Identified Aboriginal cultural assets and values

Please provide any comments you may have on the identified Aboriginal cultural assets and values on the floodplain.

Draft Billabong Creek Floodplain Management Plan

Figure 2. Proposed Floodway Network for the Billabong Creek floodplain

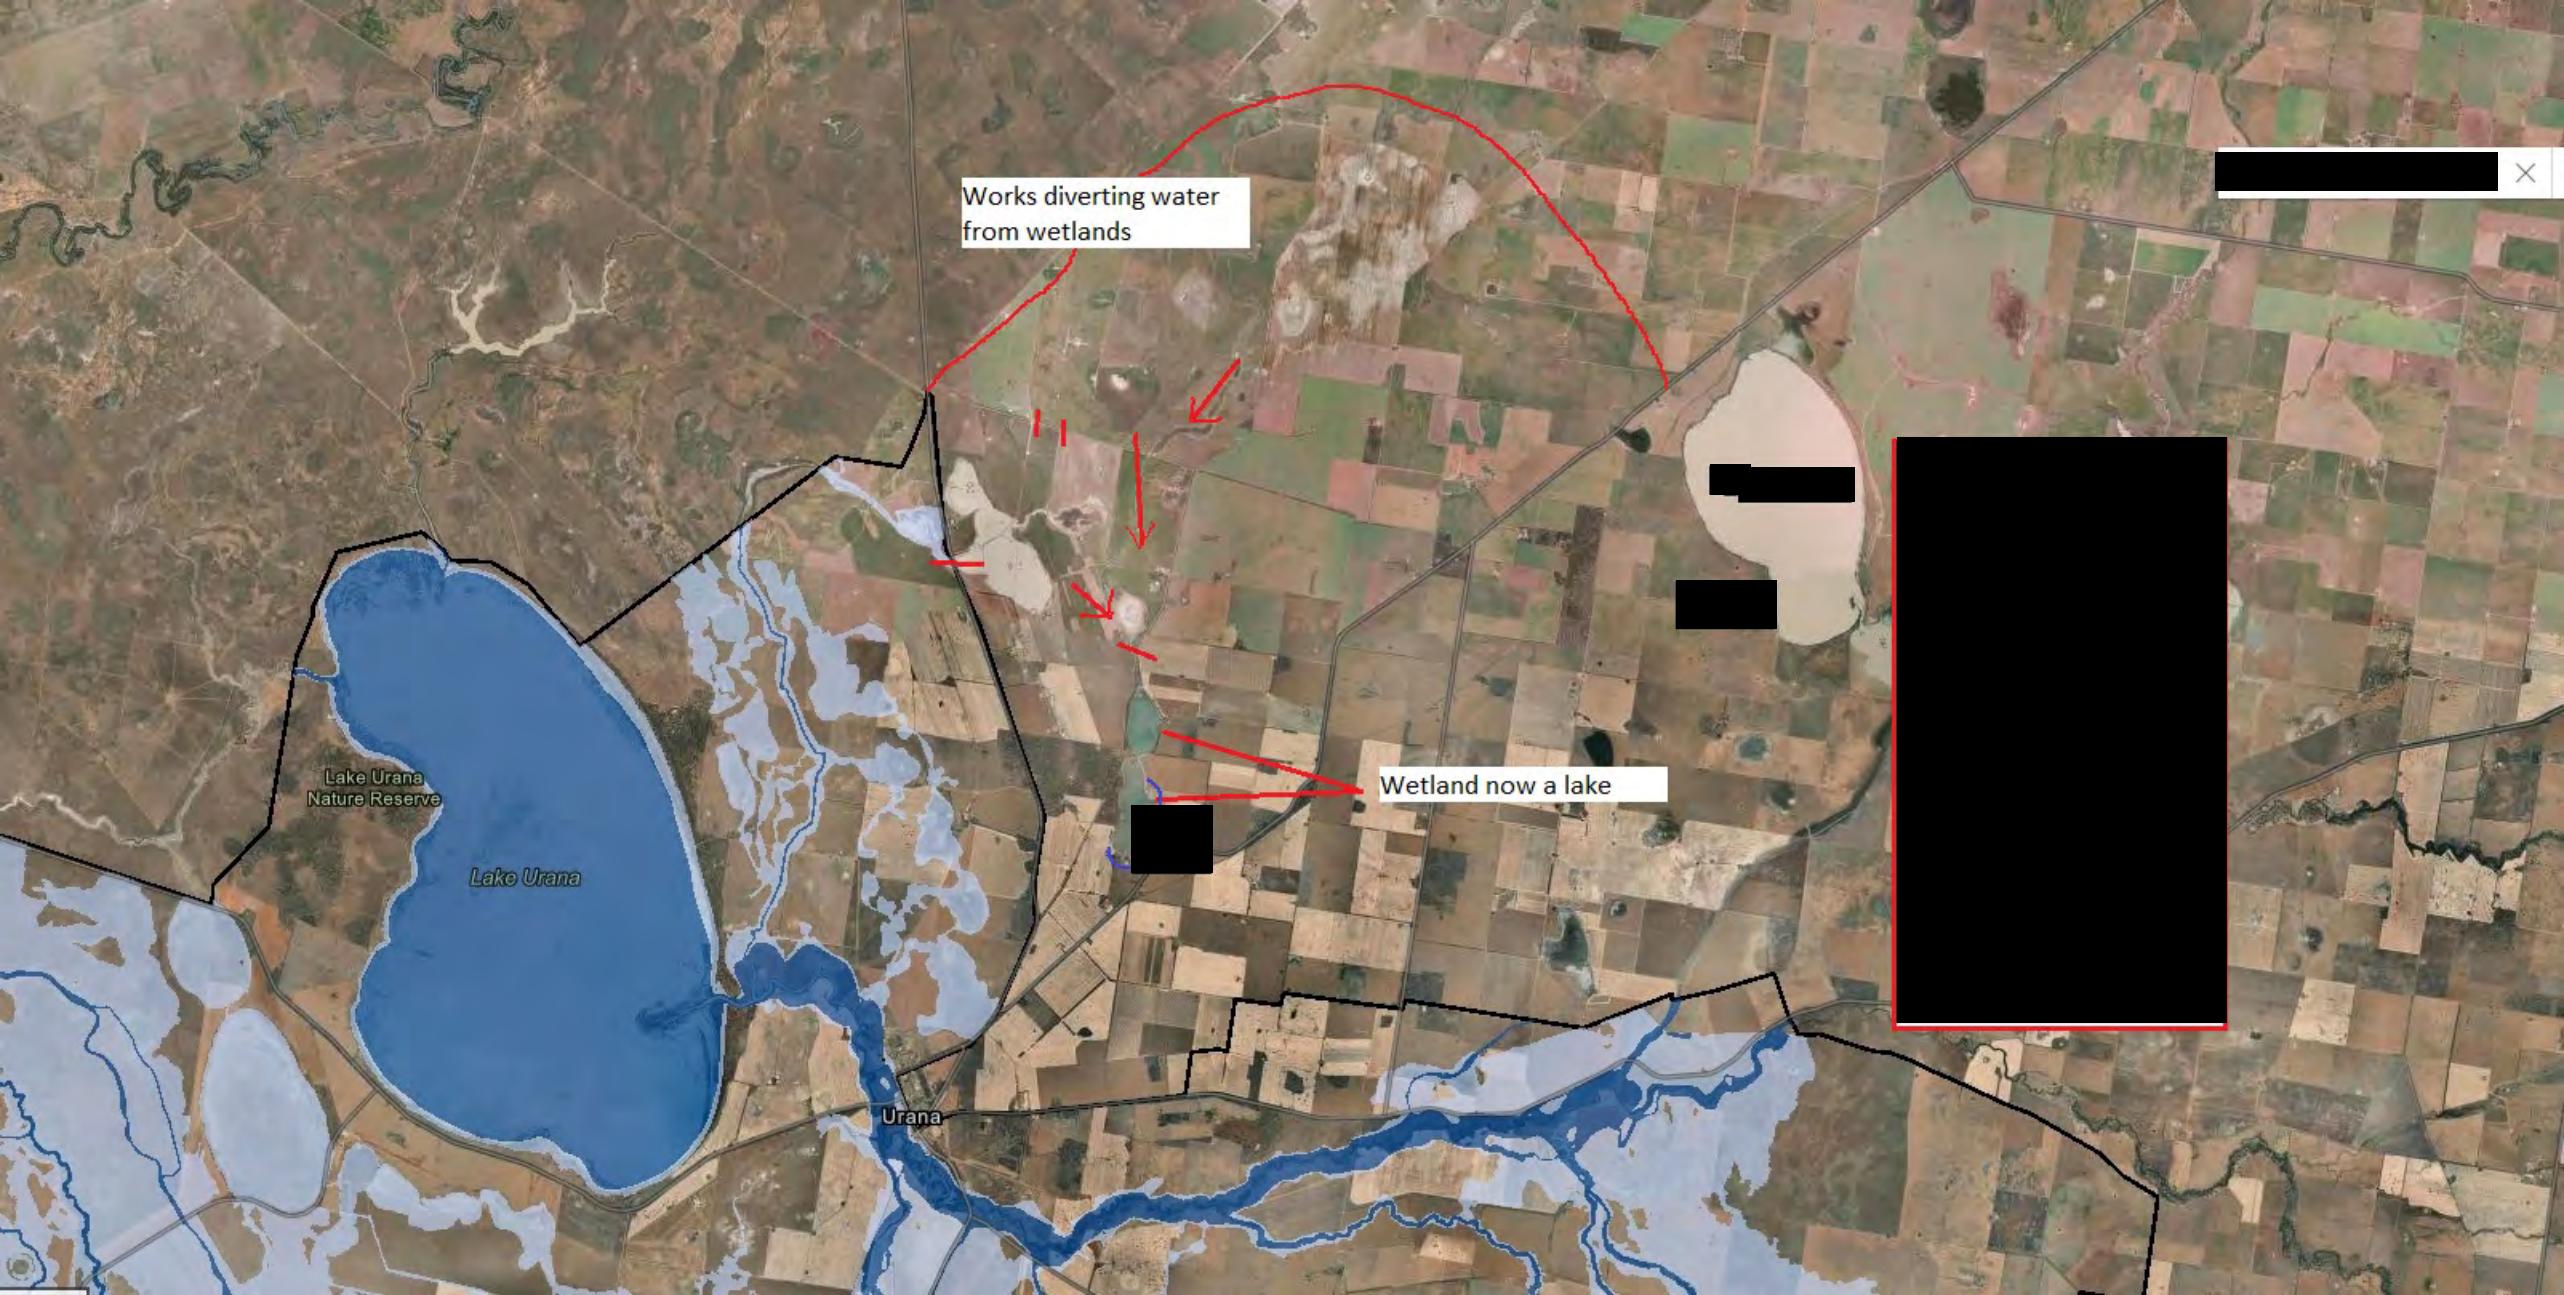
Flood extent generally either side of the creek bed

Does not flood here

This is a storage dam

Works diverting water
from wetlands

Wetland now a lake

Proposed floodway network

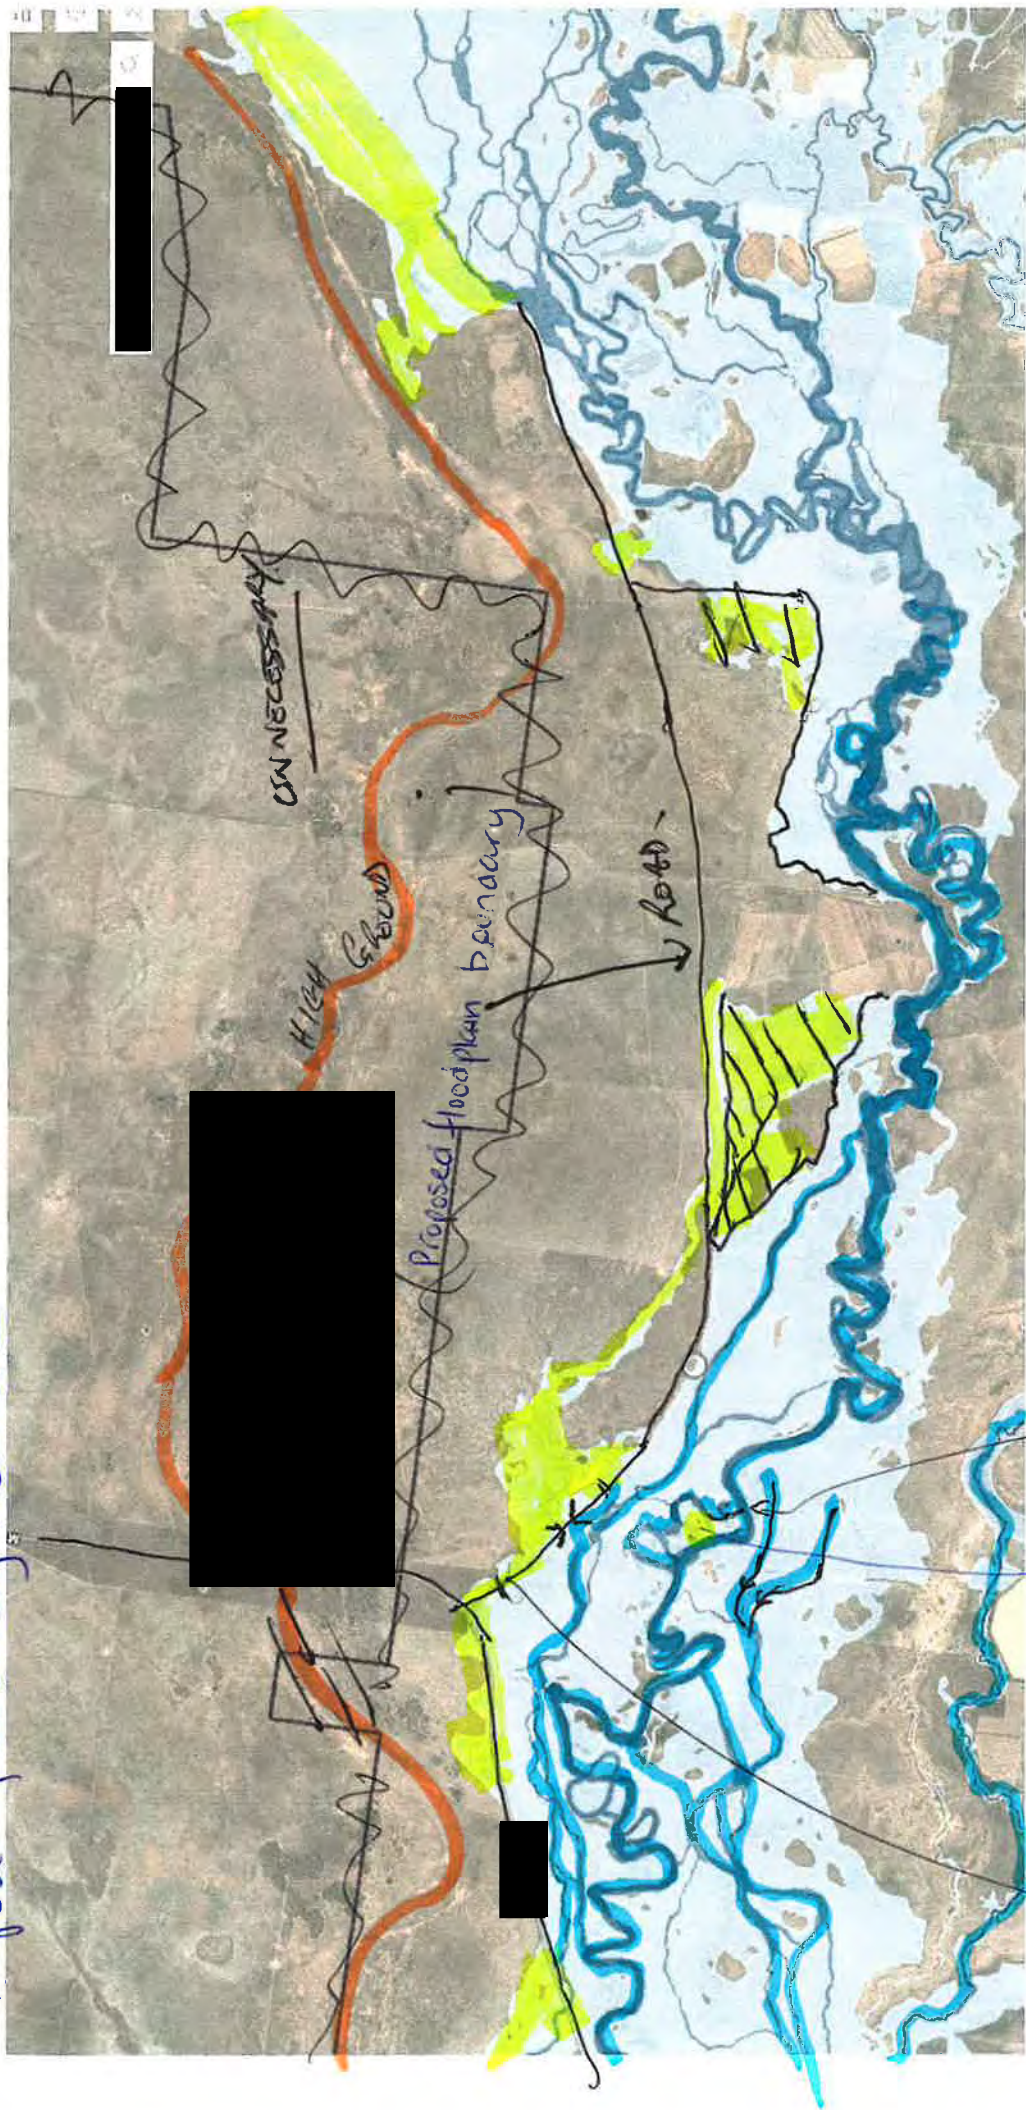
NOT IN FLOODWAY - LAND FLOODWAY AFTER HEAVY RAIN

THIS IS FLOOD

Suggested floodplain boundary

NOT A FLOODWAY

LAND FLOODWAY FOLLOWING 60mm 7 Rain

NOT WETLAND - USUALLY DRY AS

BOX FLOODED BY BACKUP DUMBORECK CAUSED BY HIGH FLOODS @ HOWLAND.

NOT WETLAND - ONLY FLOODED AFTER HEAVY RAINFALL

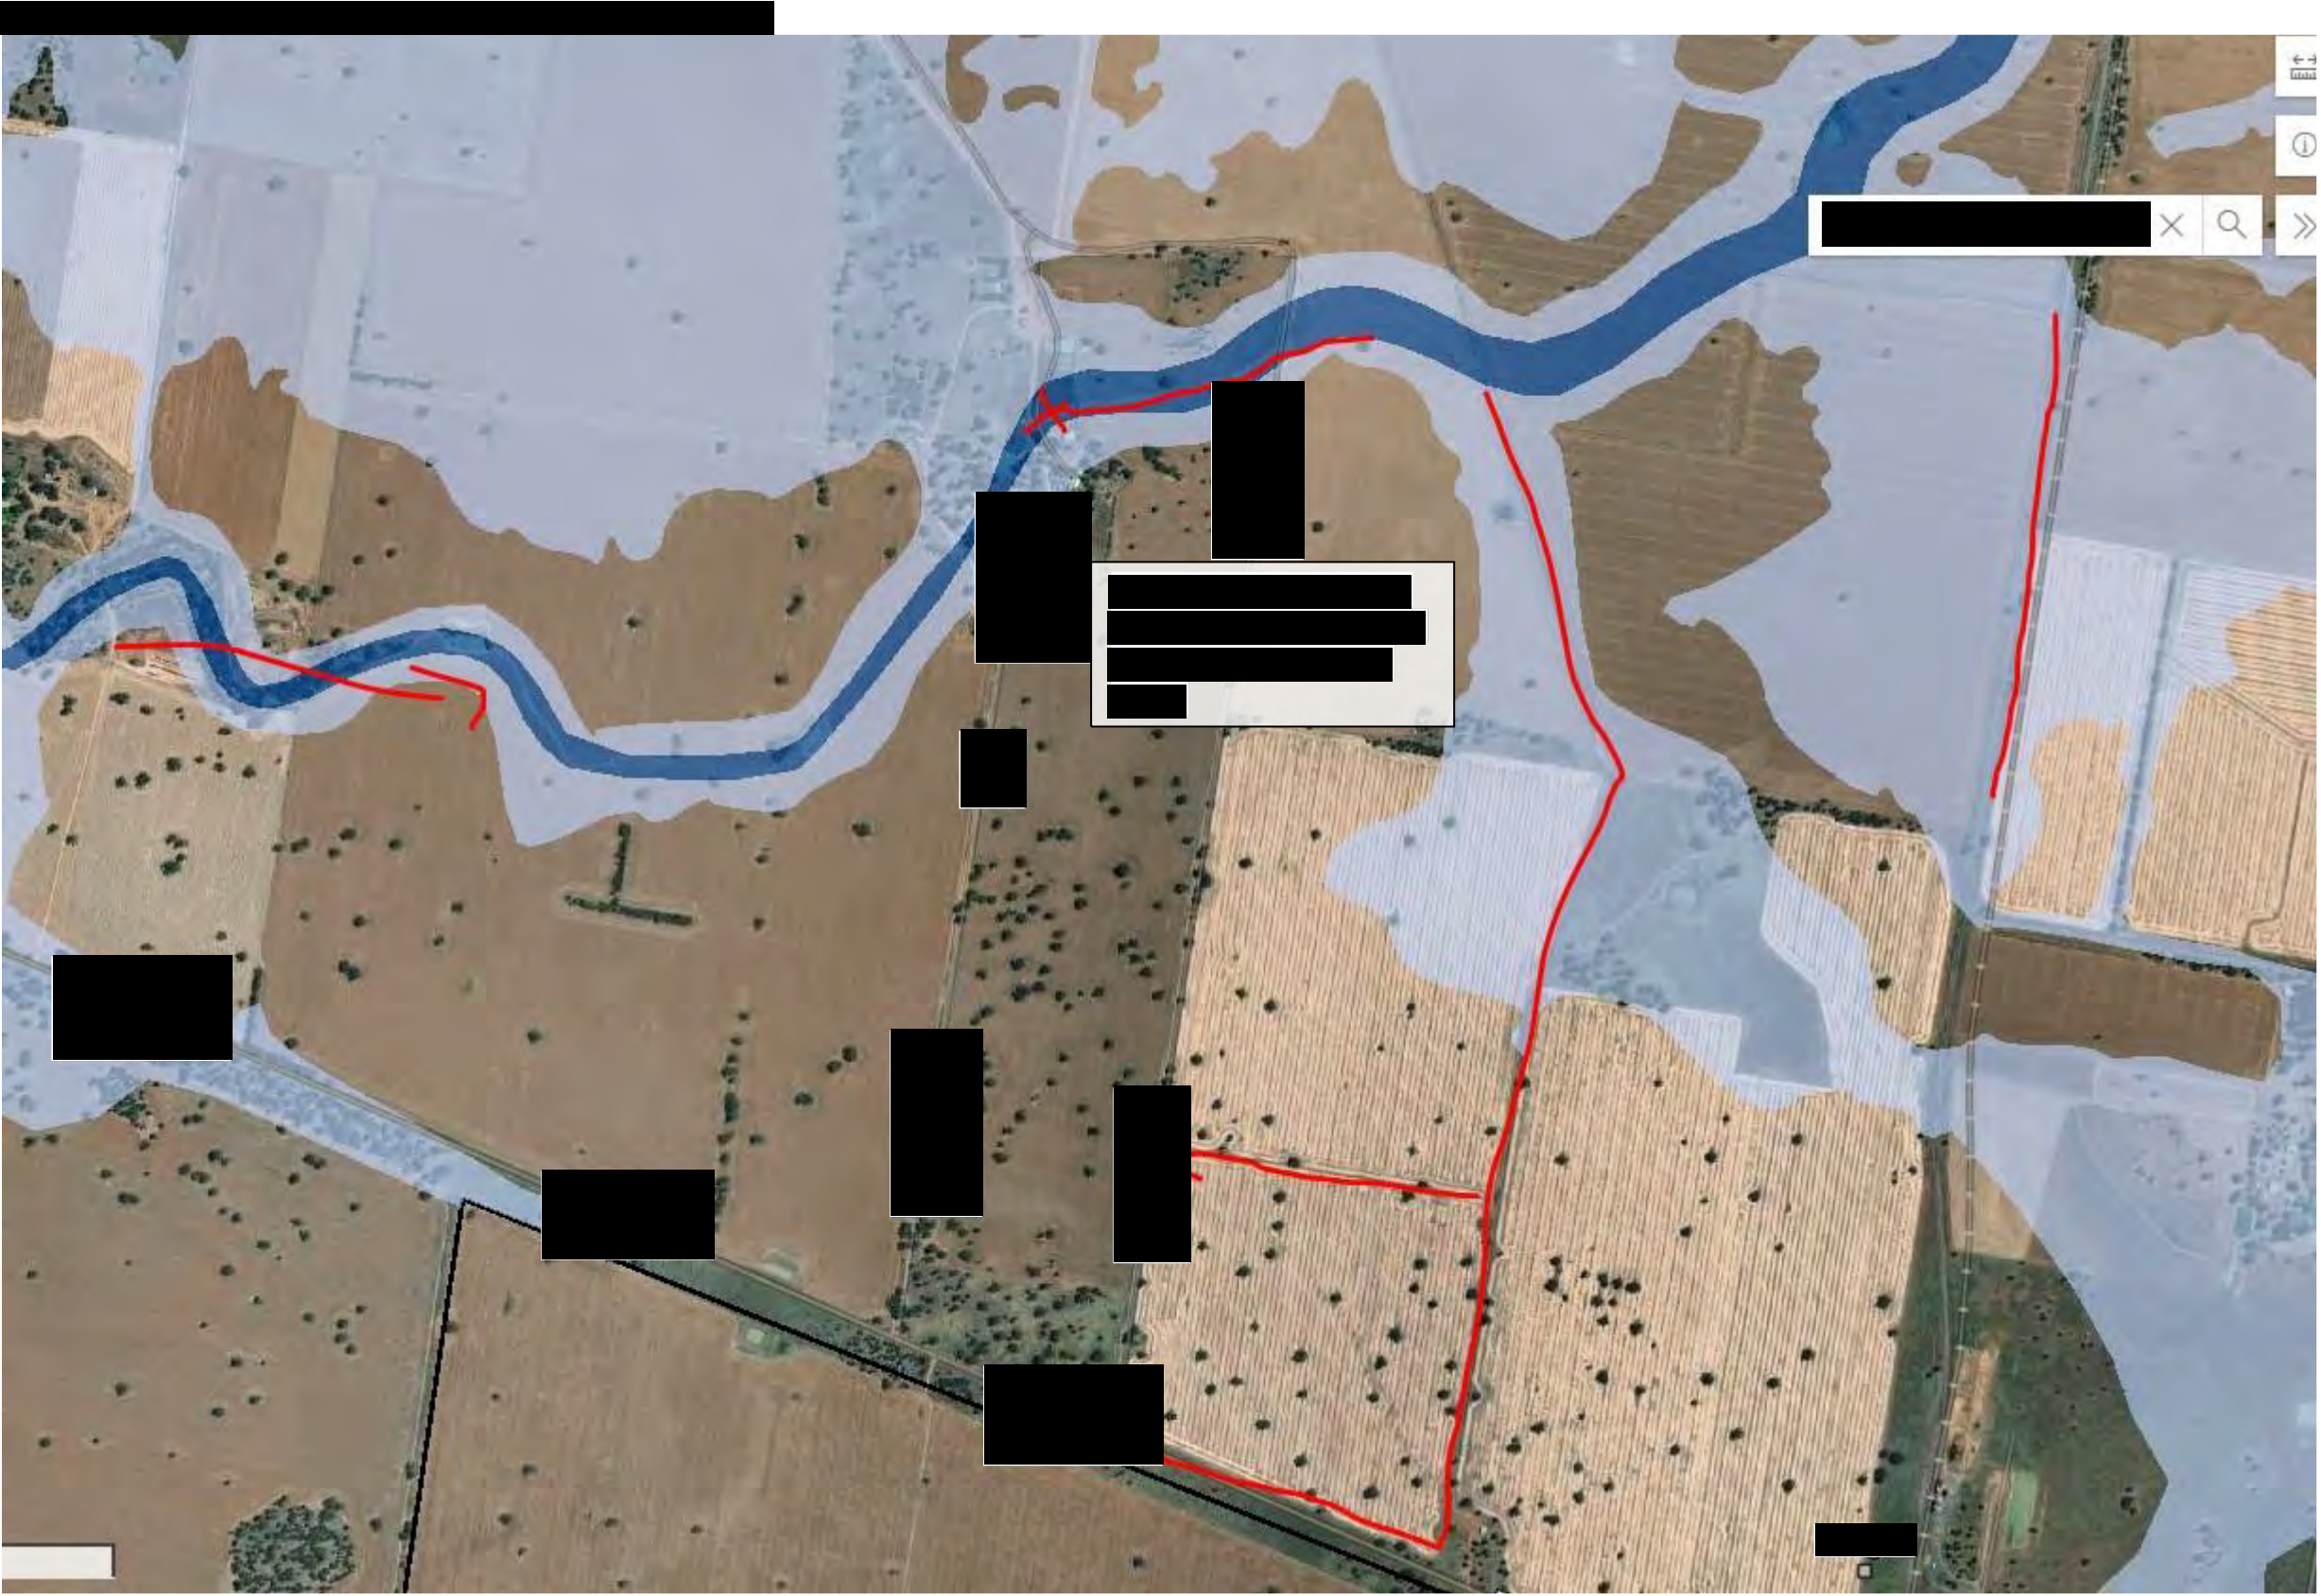
Do not want
flow this way

This bank prevents flow to the north

Need a 500m wide floodway here 50/50 split between neighbours to get this open. Overtops existing bank.

Do not want this floodway
